PRE-HEARING  
GROUND-WATER DISCHARGE PLAN ANALYSIS  
for  
HOMESTAKE'S URANIUM MILL NEAR  
MILAN, NEW MEXICO  
HOMESTAKE MINING COMPANY

GROUND WATER SECTION  
GROUND WATER QUALITY AND HAZARDOUS WASTE BUREAU  
NEW MEXICO ENVIRONMENTAL IMPROVEMENT DIVISION

January 1984

FIGURE 21. PREDICTED SELENIUM CONCENTRATIONS 1000 FEET DOWNGRADIENT OF FELICE ACRES

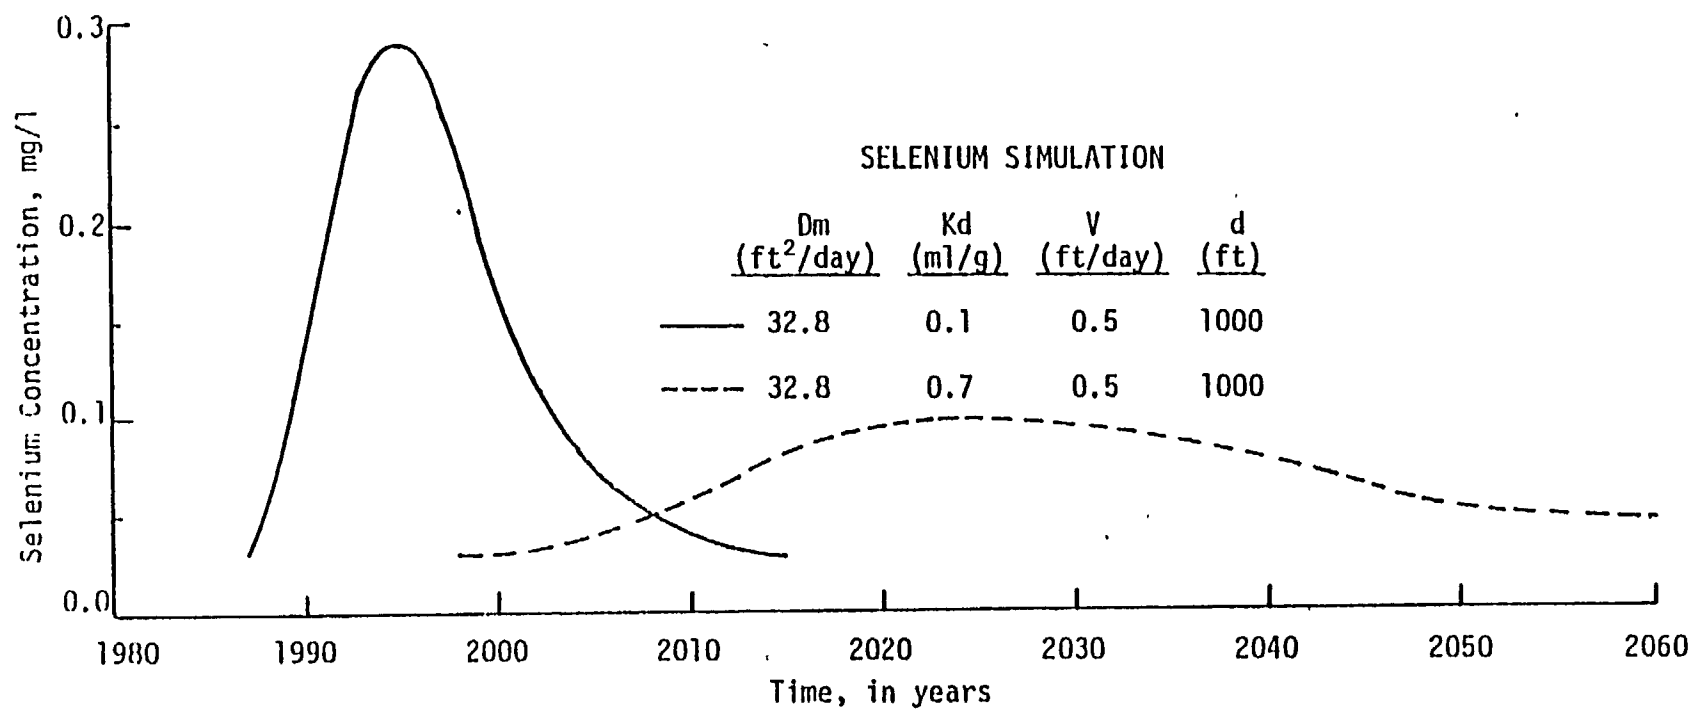
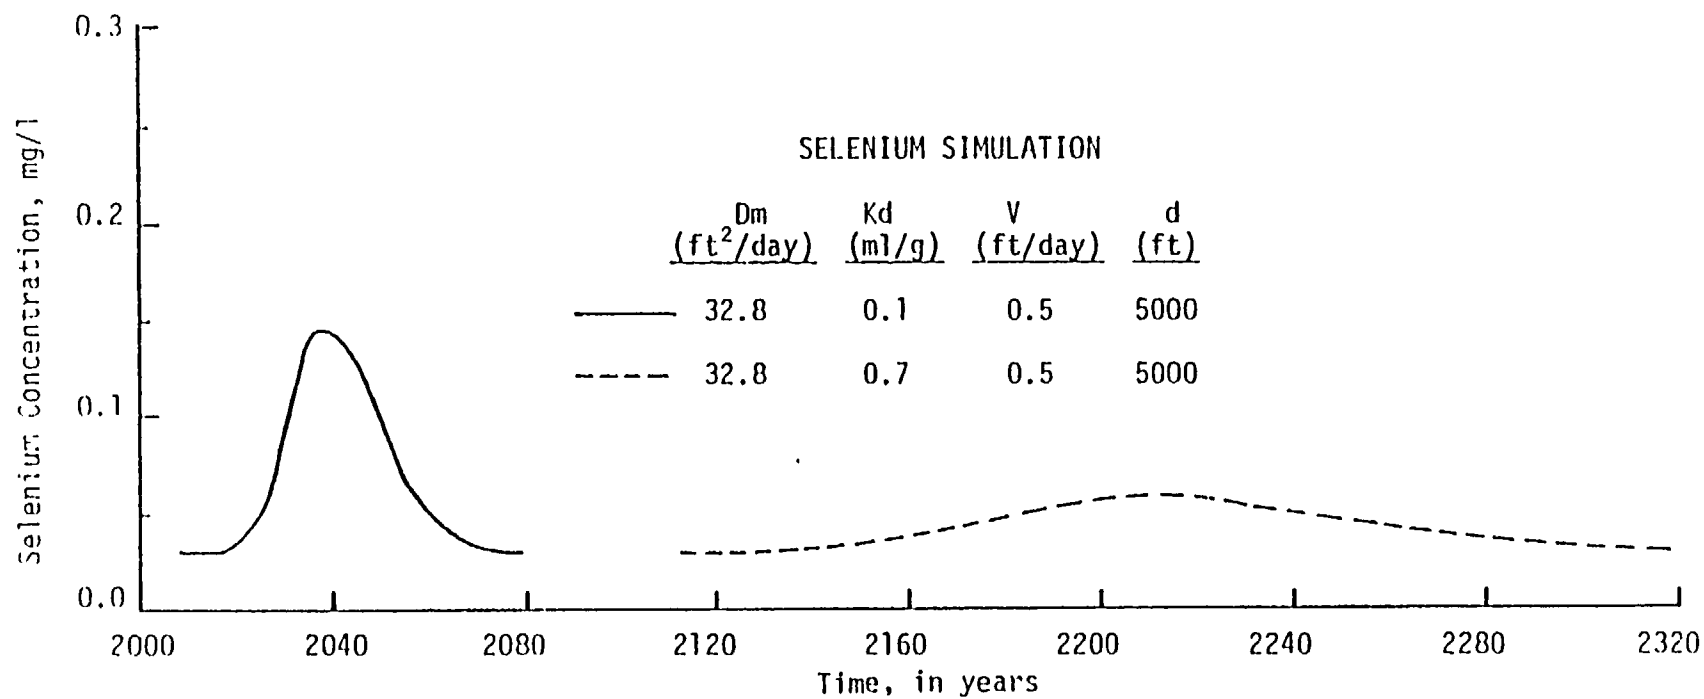
The U.S.G.S. solute transport numerical model was also used by the EID to determine the accuracy of parameters used in the Homestake model. Simulation involved the use of the same grid spacing and aquifer parameters. However, discharge was added for the inactive-tailings reservoir and the water table was calibrated using a constant head rather than constant flux boundary. Results of the EID simulation indicate that

the observed sulfate distribution cannot be calibrated if the active-tailings reservoir seepage is 150 gpm and the inactive-tailings reservoir is assumed to discharge at 75 gpm. The reason for this is that high concentrations move farther down-gradient than actually observed. Therefore, Homestake's use of 75 gpm, discharging from the active-tailings reservoir and no discharge from the inactive-tailings reservoir, appears to be valid. However, the EID calibration was not able to match the extent of sulfate attenuation down-gradient in Broadview, Murray and Felice acres with the dispersivities and concentrations in the discharge used by Homestake in their ground-water model. This implies that the two-dimensional model may be influenced by movement in the 3rd or vertical-dimension. The fact that tailings seepage has reached ground water in the upper Chinle substantiates that this is occurring.

Because Homestake accounted for this discrepancy by changing discharge rates and concentrations until the model was calibrated, the flow system and concentration distribution projections are probably correct. However, the modeled seepage rates and concentrations are probably lower than actual rates and concentrations because of flow in the 3rd-dimension which was not accounted for in the Homestake model.
